TM-899

CCI Report No. 390-111

DESIGN EVALUATION OF VALVE ACTUATOR CAMS
(FERMILAB. RECIPROCATING DESIGN)

PREPARED UNDER FERMILAB SUBCONTRACT NO. 94199
BY CRYOGENIC CONSULTANTS, INC.
ALLENTOWN, PA.

FIGURE 5

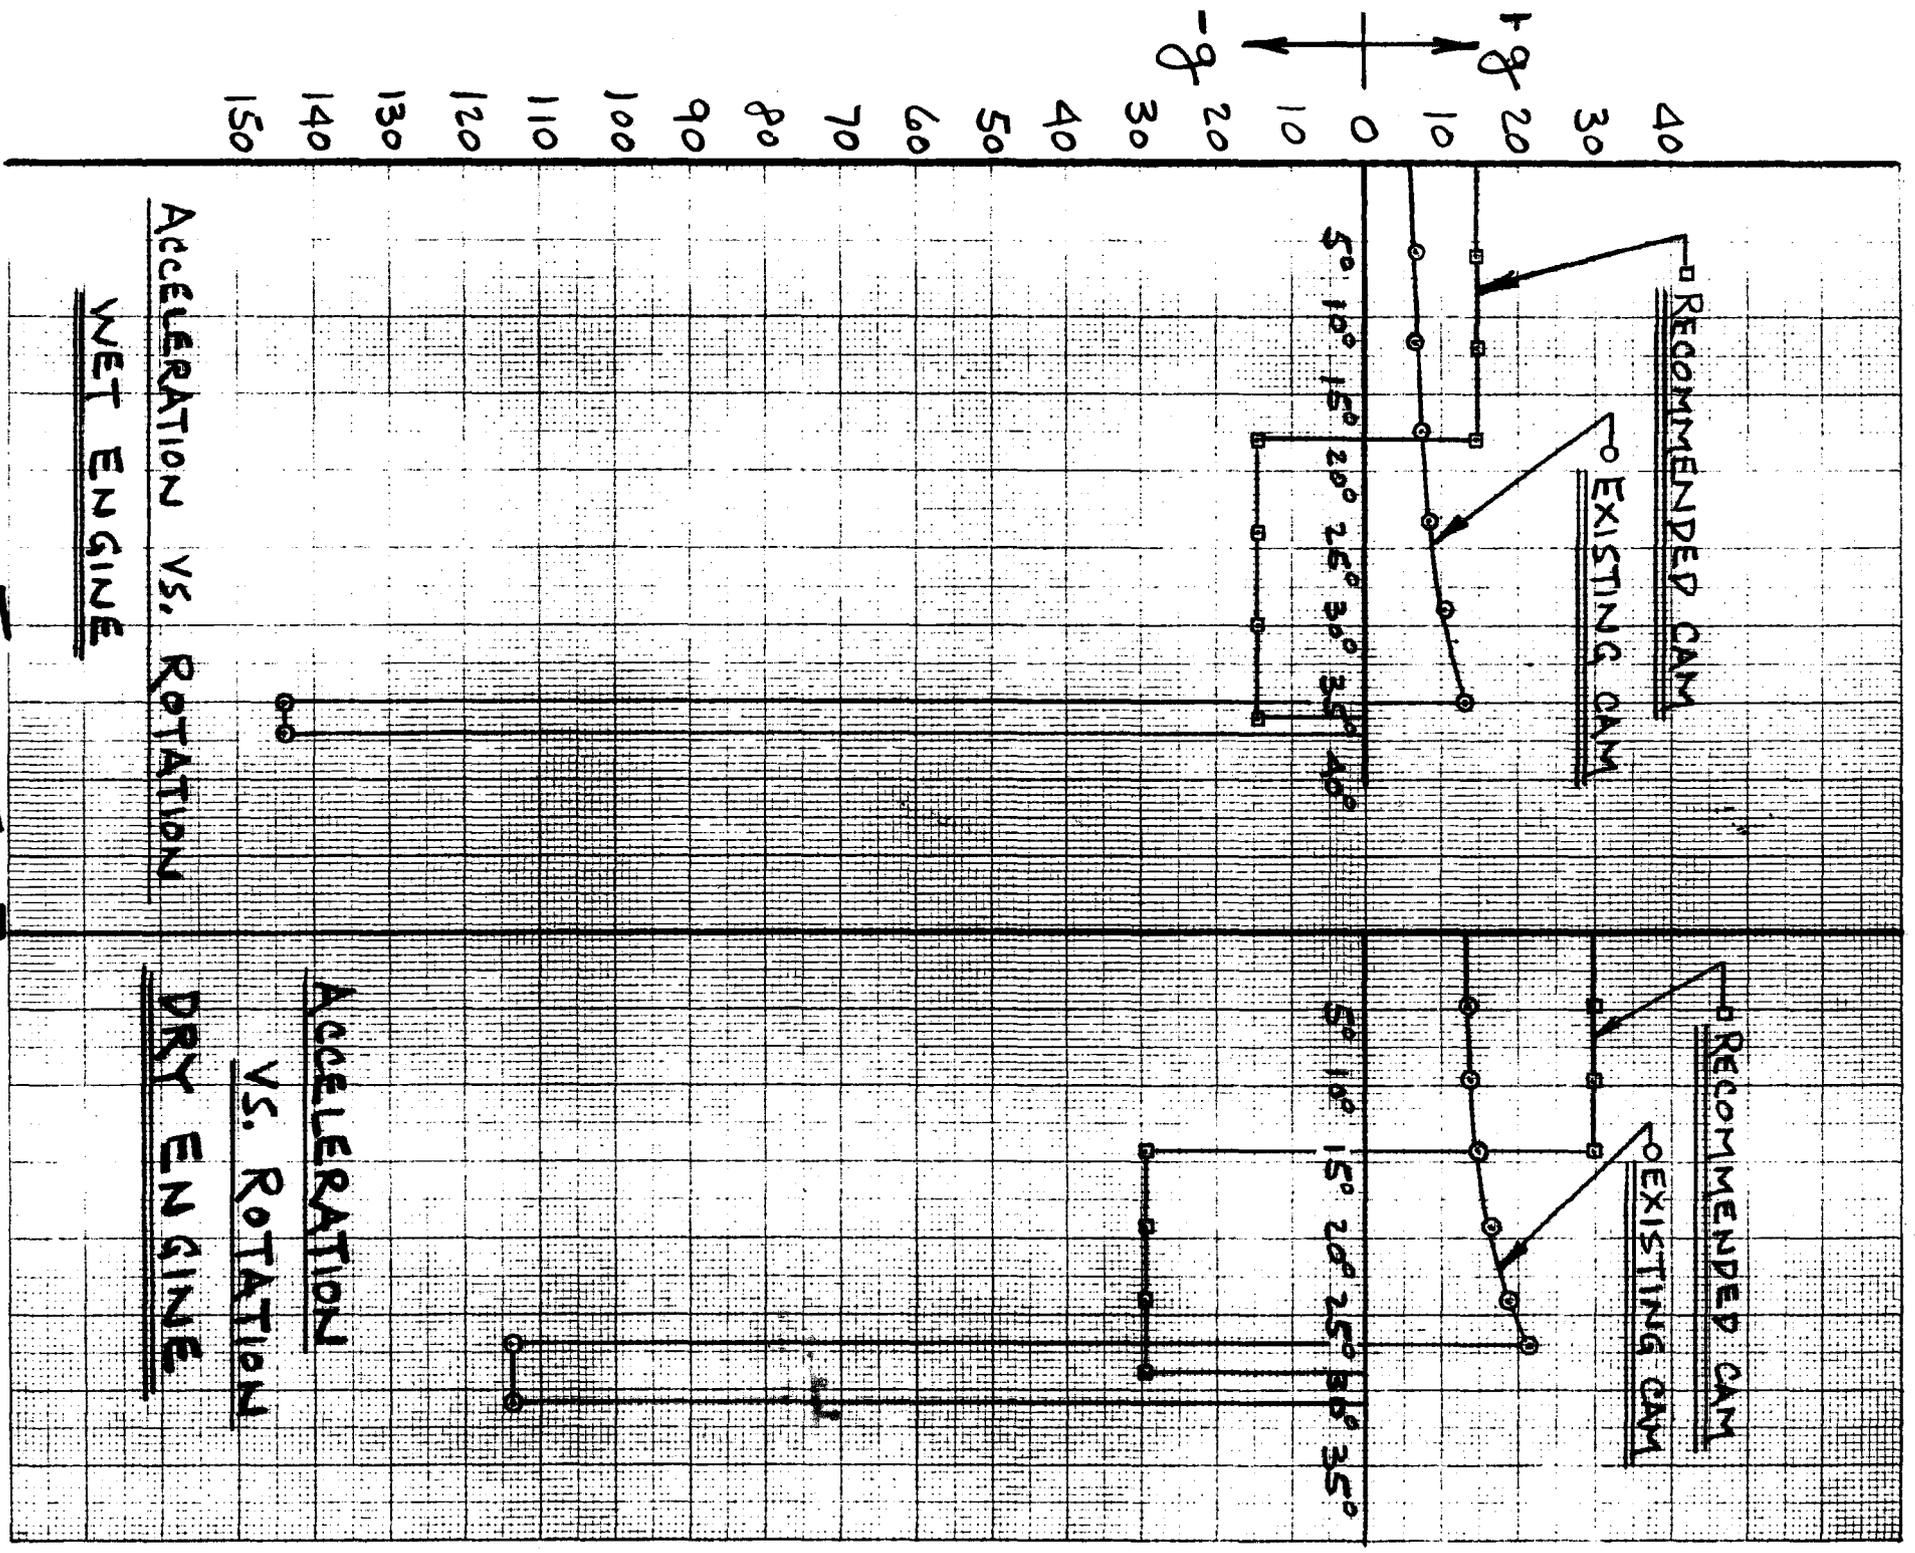
By comparing the original cam profile with the recommended profile it can be seen that the original profile develops a lower but constantly increasing acceleration (6.2g to 13.0g vs. 14.8g for the wet engine and 13.3g to 21.8g vs. 29.7g for the gas engine.).

However, at peak lift the original profile requires exceedingly high acceleration forces to hold the follower against the cam. This is true both at the end of the opening stroke and at the start of the closing stroke. For either case, insufficient spring force will not hold the follower against the cam.

The acceleration produced by both the existing cams and the recommended cams is shown graphically in Figure 5. Keep in mind that due to the sign convention in all the calculations, the positive "g" is the acceleration of the cam follower due to the cam profile while the negative "g" represents the acceleration required from spring forces for the cam follower to remain in contact with the cam during the deceleration of the follower.
